# CITY OF SACRAMENTO

- SUBJECT: 1. Environmental Determination  
2. Tentative Map (P85-340)

LOCATION: East side of Pocket Road, south of drainage canal

# TENTATIVE MAP FOR POCKET 4

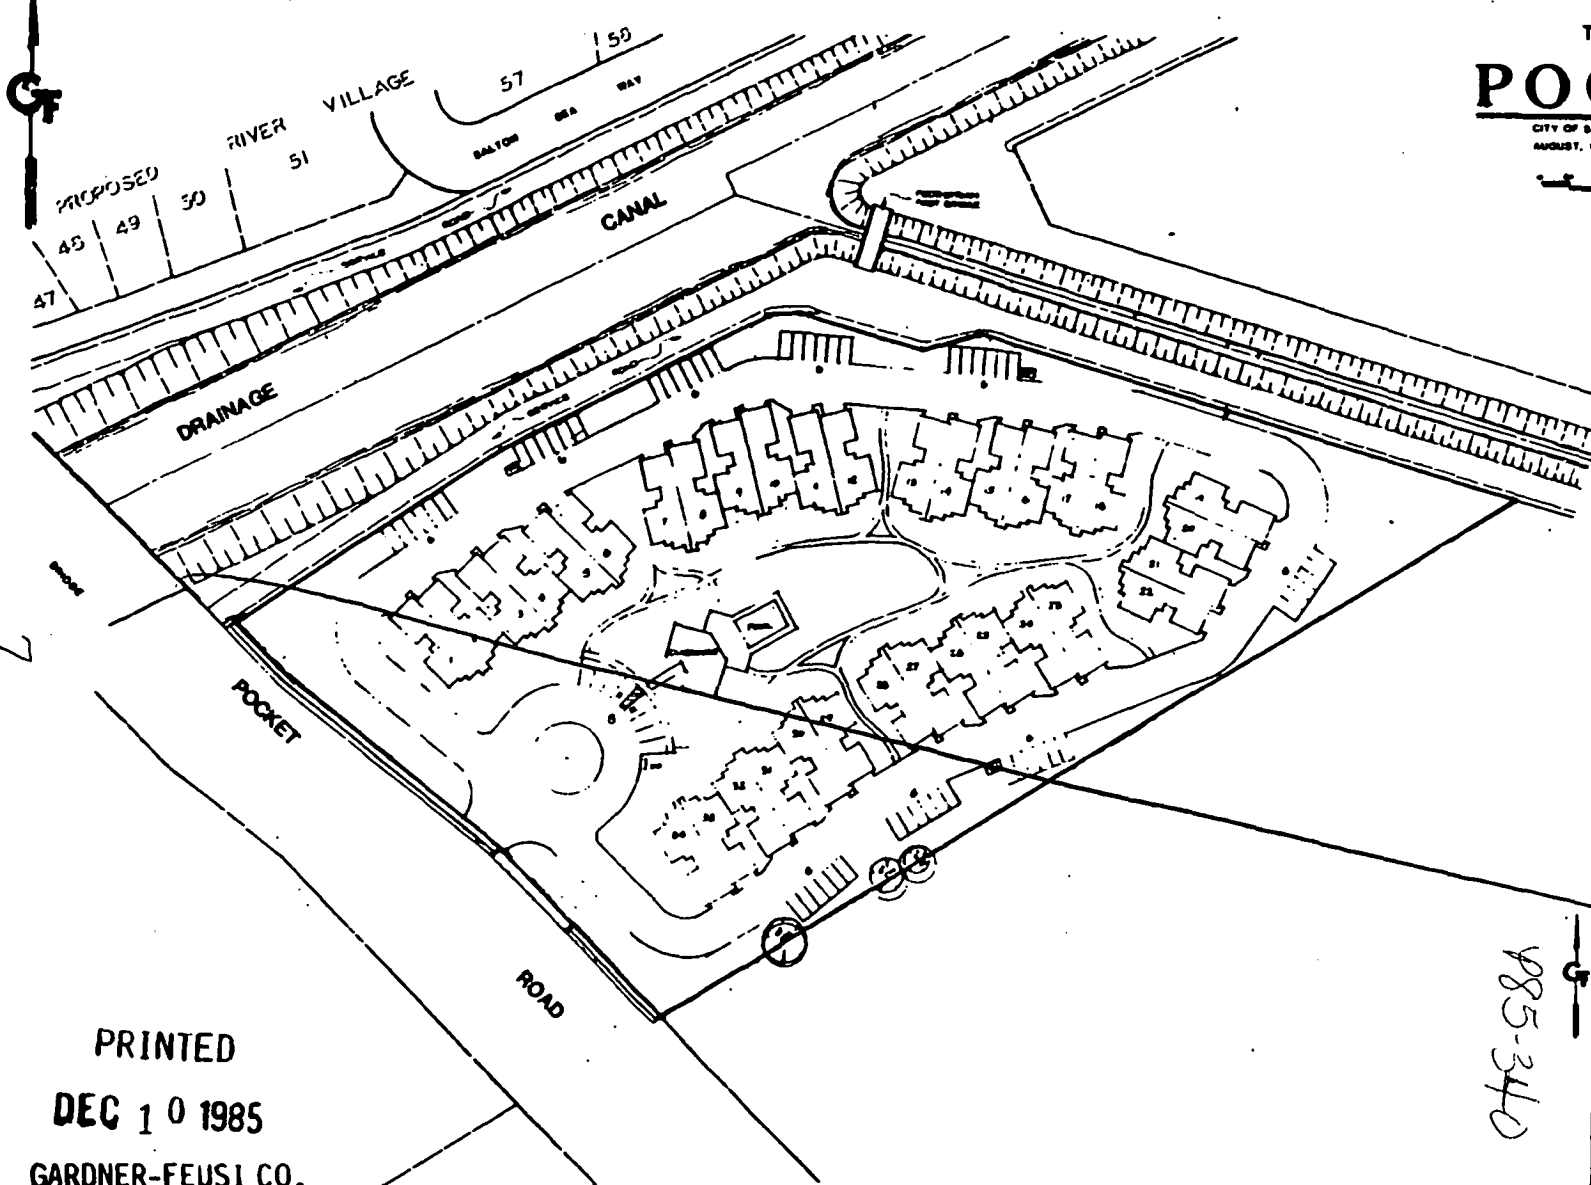
8. Eliminate divided driveway.

Guarantee minimum 20' east/west canal parkway to the City to satisfaction of Community Services Director.

- 9. ~~Provide 20' east/west canal parkway to the City.~~ (Canal landscaping if provided by developer, shall conform to the Canal Parkway Master Plan. Plans shall be reviewed and approved by the City Landscape Architect.)
- 10. Minimum lot pad grade +3.5 feet; minimum gutter grade +2.0 feet.
- 11. Submit a supage study prepared by a registered engineer which addresses and recommends solutions for groundwater problems which may occur within both the subdivision and public right of way. Appropriate facilities shall be constructed to alleviate those problems.
- 12. Show reciprocal easements on final map.
- 13. Pay Pocket Bridge fees.
- 14. Final map cannot be filed until improvements of the Pocket Road A/D #2 are complete to the satisfaction of the Public Works Director.

- h. Eliminate divided driveway.
- i. Guarantee minimum 20' east/west canal parkway to the City to the satisfaction of Community Services Director. (Canal landscaping if provided by developer, shall conform to the Canal Parkway Master Plan. Plans shall be reviewed and approved by the City Landscape Architect.)

FRONT ELEVATION  
SCALE: 1/8" = 1'-0"

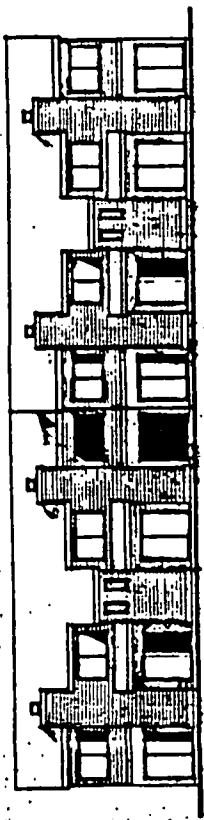
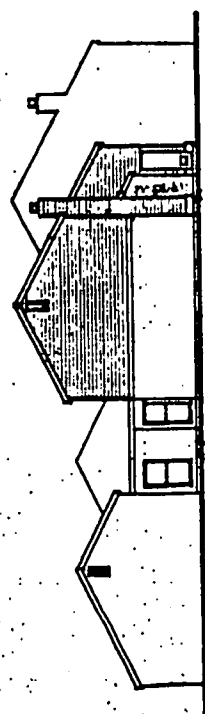
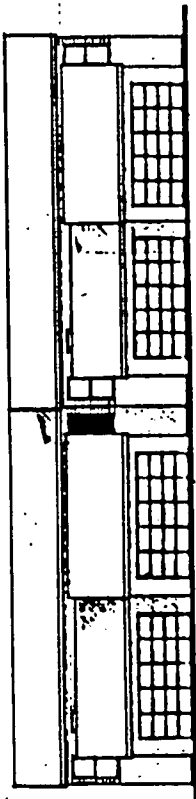
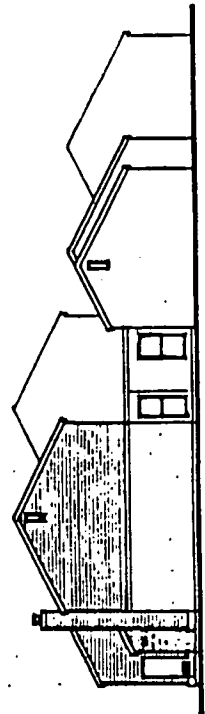
As proposed, the townhouses would be constructed with lap siding and composition shingles. Staff suggests that the composition shingles be replaced with wood shingles/shakes, which is keeping with the other residential developments in the Pocket area. The applicant has indicated that the floor plans and elevations are conceptual only (see Exhibit D) and staff has provided the applicant/owner for approval of any revised plans. The plans do not include the location of trash enclosures or a landscaping/irrigation plan. These items must be included on a revised site plan which is subject to review and approval by the Planning Director prior to the issuance of any building permit. The site plan indicates that three trash enclosures will be located on the site (two on the north side and one on the south side). Staff recommends that an additional trash enclosure be located along the south side of the site. (added by staff)
